Access Compliance Report to accompany a

Development Application

Development Address: 682 Castlereagh Road, Agnes Bank, NSW 2753

Client: Vraj Sydney Pty Ltd.

FLOOR PLAN

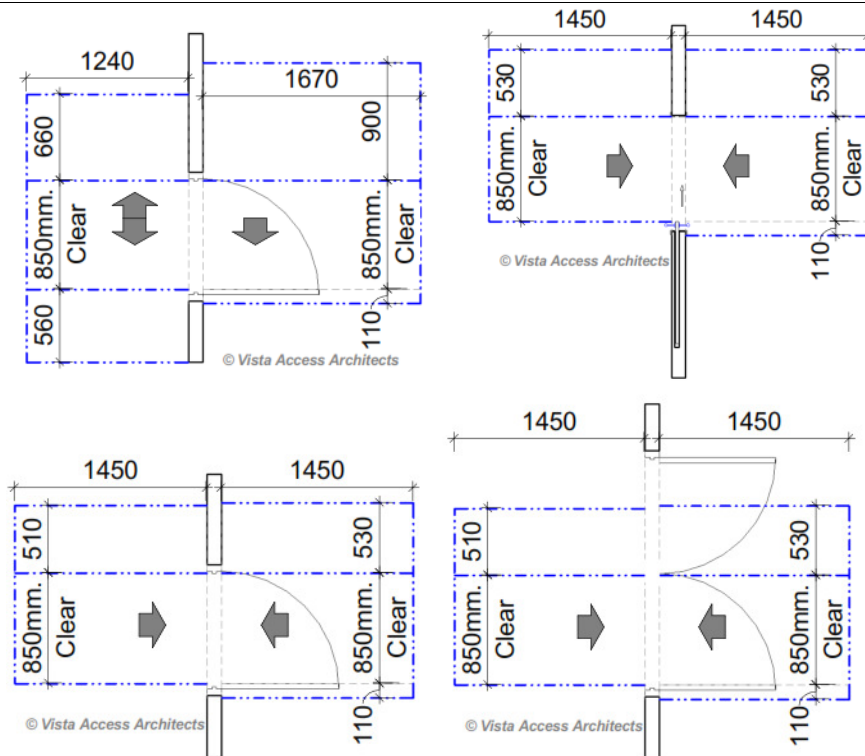
<p>Compliance Comments</p>	<p>Capable of compliance.</p> <p>As stated in the above requirements, APS only applies to,</p> <ul style="list-style-type: none"> - New works, - Modified works and - Works within the 'affected part' <p>In this development, the new works, modified works and works within the 'affected part' have been shown in the plan below with a <u>red boundary</u> and include:</p> <ul style="list-style-type: none"> - Driveway and main pedestrian entry points - Accessible parking, connecting ramps and pathways - New deck and new sanitary facilities - Internal additions and alterations to main hall - Additions and alterations to garage to be used as art room
